RICHARD L. MEEHAN, CONSULTING ENGINEER
meehan@stanford.edu

RE: Vista Pacifica Development

POTENTIAL GAS HAZARDS BENEATH THE PROPOSED VISTA PACIFICA DEVELOPMENT

Figure 1. Map showing some of the injector wells just to the south of the Vista Pacifica area. The Castle fault is shown in yellow

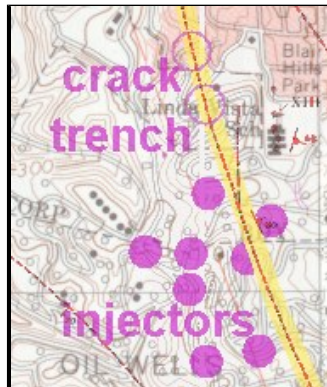
The BYA reviewer's dismissal of the significance of injector wells as close as 400 ft. from property line, and his claim that there are no similarities between conditions at Baldwin Hills, Fairfax, and Vista Pacifica are neither documented nor referenced. In fact injection wells at the Vista Pacifica site are actually closer to the proposed new houses than wells at Baldwin Hills and Fairfax were to the areas of disastrous damage to the Baldwin Hills Reservoir and Ross Store.

In this connection I have noted active ground cracking on Wrightcrest Drive, figure 2 below. This almost certainly represents activation of extensions of the well-known "Castle Fault" which passes beneath some of the proposed new houses. Note from the map, figure 1, that the crack is just north of the project and that active injection wells are just to the south of it. It is likely that the same cracking effect exists beneath the area of proposed houses, though not observable in the eroded and graded terrain in the project area. Note also from the map above that the Lettis trench which identifies the Castle fault as actually present in the project along the same alignment.

*Figure 2. Ground crack, Wrightcrest Drive,
1999*

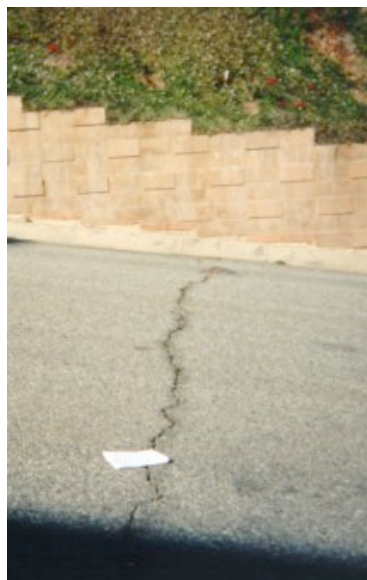
Since the early 1980s oil field extraction and water injection operations have been expanded into and adjoining the project area. The nearest injection well to the Wrightcrest Drive crack site (#118) was placed in operation in late 1995 and is currently injecting at a rate of about 50,000 bbl/mo. Injection pressures (400-550 psi) in relatively shallow producing zones (e.g. Vickers Zone at 1500 feet) are similar to those associated with thousands of feet of ground cracking which led to failure of the Baldwin Hills Reservoir on the southeast side of the oil field. These pressures exceed calculable fracture pressures and were considered by the USGS, as well as ourselves, as probable causes of ground failure at Baldwin Hills. This issue remains unaddressed in the environmental and geotechnical studies provided, including the BYA review which simply dismisses without attribution the potential as "not widely accepted".
